Sneak Circuit Analysis of F-4C Flight Control System

D2-118545-1

F-4C

F33657-74-C-0686

Control Amplifier, P/N 230E420G4, Ref. Des. 65-AR305

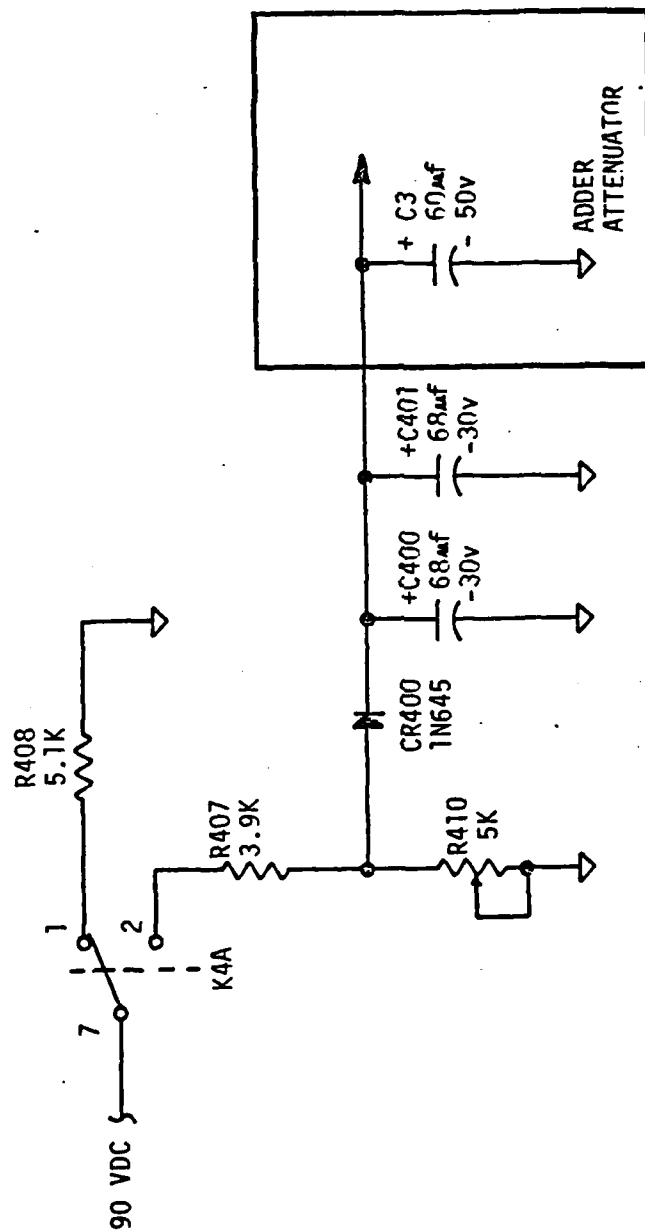
Capacitors C400, C401 in the chassis wiring and capacitor C3 in the Adder Attenuator are connected in parallel as shown in the attached figure. The working voltage for C400 and C401 is 30 volts and for C3 is 50 volts. Per reference 2, the nominal voltage across these capacitors is 31.9 volts. Depending upon the setting of R410 this can be as high as 39.8 volts. In either case, the working voltage for C400 and C401 is exceeded. This is in violation of MIL-STD-198C, Section 802, Paragraph 2.7.2.

Replace C400 and C401 with capacitors with sufficient working voltage to withstand the applied voltages.

Control Amplifier, P/N 230E420G4, Ref. Des. 65-AR305

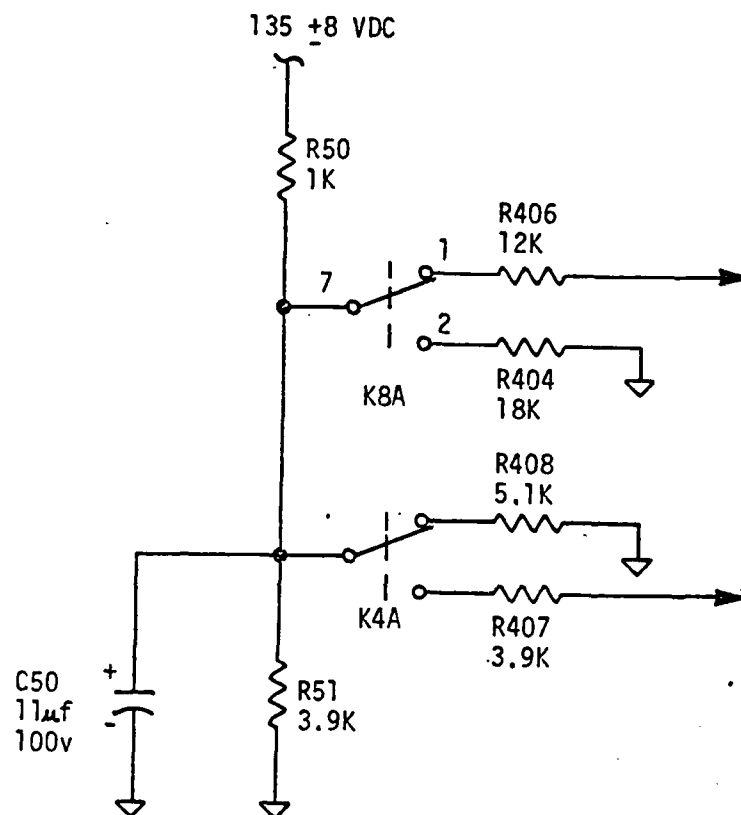
Capacitor C50 filters the 90 VDC used to control the Pitch and Roll faders in the Adder Attenuator module. During the switching time of relay K4A the voltage applied to C50 is 109 VDC due to the loss of the 5.1K Ω load impedance. This exceeds the rated working voltage of the capacitor in violation of MIL-STD-198C, paragraph 6.5(d).

Replace capacitor C50 with a capacitor with sufficient working voltage to withstand the applied voltage.

FIGURE 1 G-LIMIT ACCELEROMETER AND RELAYS

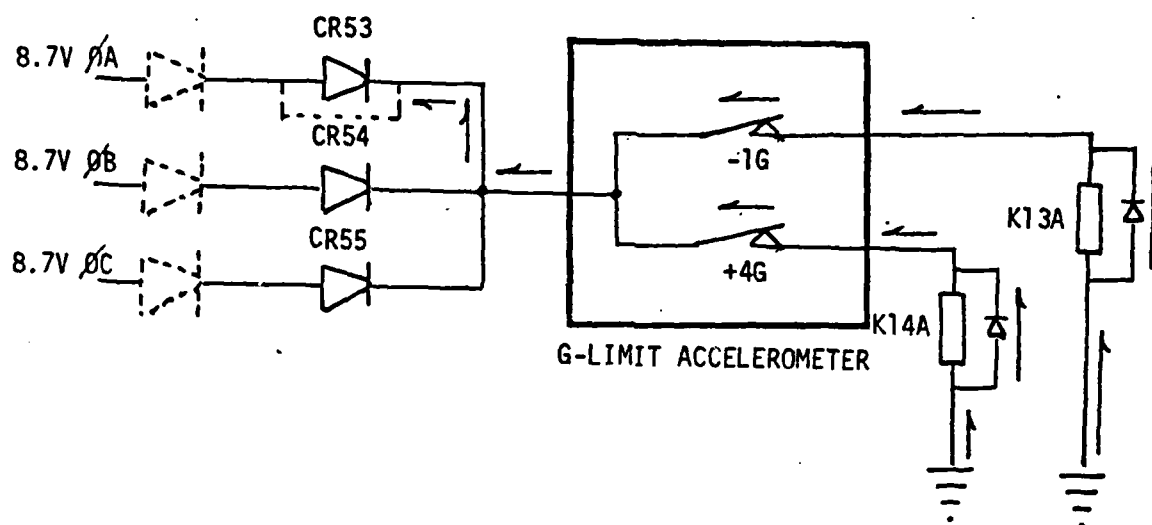
Diodes CR53, CR54, and CR55 rectify the incoming 8.7 VAC 400 Hz, 3-Phase voltage to provide 9.5 VDC to the G-limit relays through the G-limit accelerometer switches as shown in the attached Figure 1. If any of the three diodes fail in the shorted mode, the voltage to the G-limit accelerometer will be driven negative during the negative cycle of the phase containing the shorted diode. This will cause current flow through the suppression diodes of K13A and K14A in the forward direction, as shown, causing them to fail open. Also, during the negative portion of the shorted phase, the two remaining diodes will supply excessive current, causing one or both to fail open. The negative voltage at the input to the G-limit accelerometer will have the same effect as opening the G-limit switches: De-energizing of K13A and K14A and disengaging AFCS (AFCS engage logic is shown in Attached Figure 2).

Add an additional diode in series with each of the three diodes as shown in Figure 1.

T.O. IF-4C-2-16, Change 6, March 1, 1974
Figure 2-39, Change 5

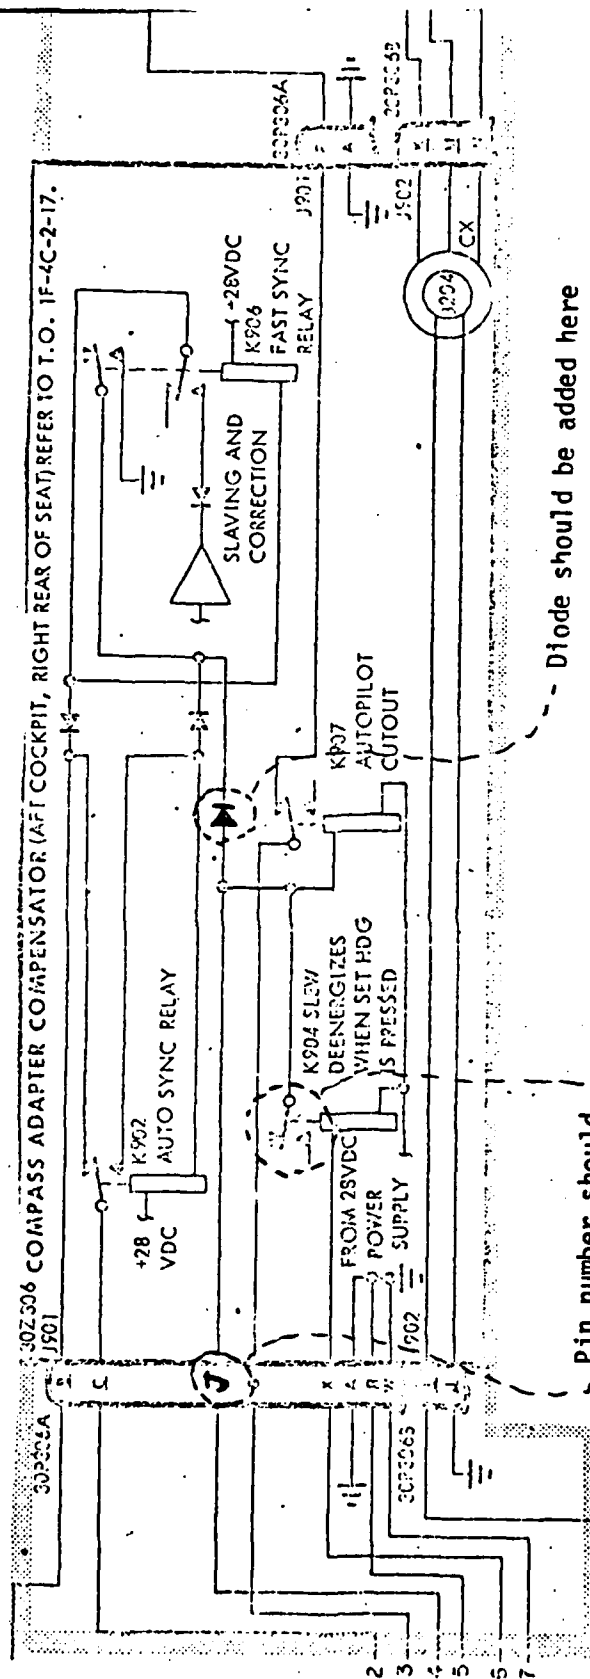
T.O. IF-4C-2-16, Figure 2-39, Change 5, disagrees with T.O. IF-4C-2-17, Change 7, April 15, 1974, Figure 2-24, Original, in the following particulars:

- 1) Pin number J was not labeled in Figure 2-39.
- 2) Diode shown on the attached sheet is present in Figure 2-24, but missing from 2-39.

Diode should be added here

Pin number should
be added here

Diode shown in T.O. IF-4C-2-17, Figure 2-24, should be added to T.O. IF-4C-2-16, Figure 2-39.

Pin J" on connector 30P306A should be added to Figure 2-39.

1) T.O. 5A1-2-42-2, Figure 5-12, Change 2

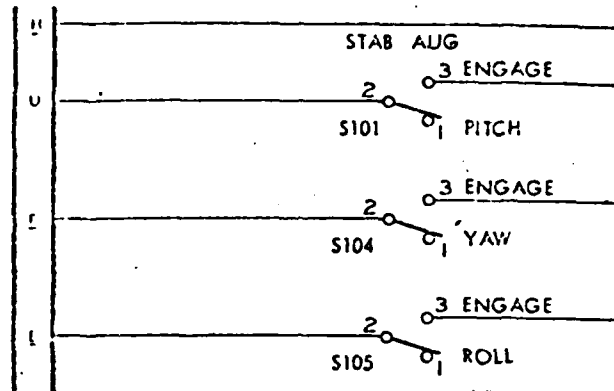
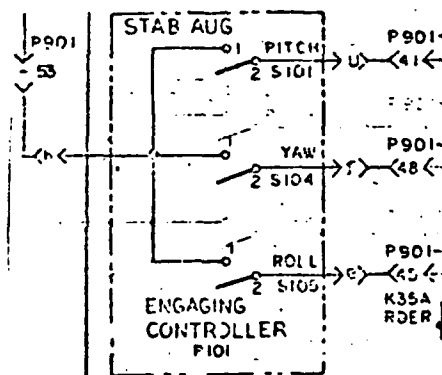
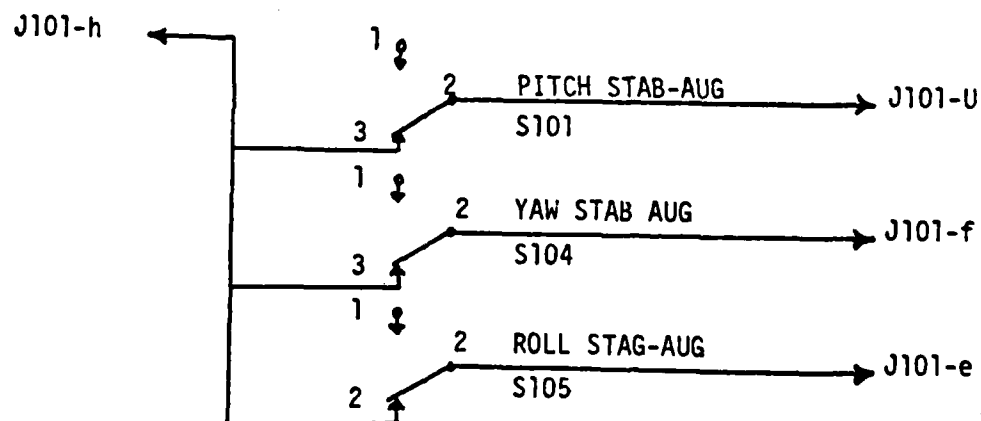
- 1) T.O. 5A1-2-42-2, Figure 5-12, Change 2
Normally Open, Latching. H common to all pin 3 contacts.
- 2) Schematic, Electrical-System AN/ASA-32M Control Circuits
Drawing #281E402, Sheet 4, Revision A, 2-16-71
Normally Open, Latching. H common to all pin 1 contacts.
- 3) Schematic, Electrical-Engaging Controller
Drawing #702187, Rev. C, 5-7-69
Normally Closed, Momentary. H common to all pin 3 contacts.

Insufficient information to determine correct configuration.
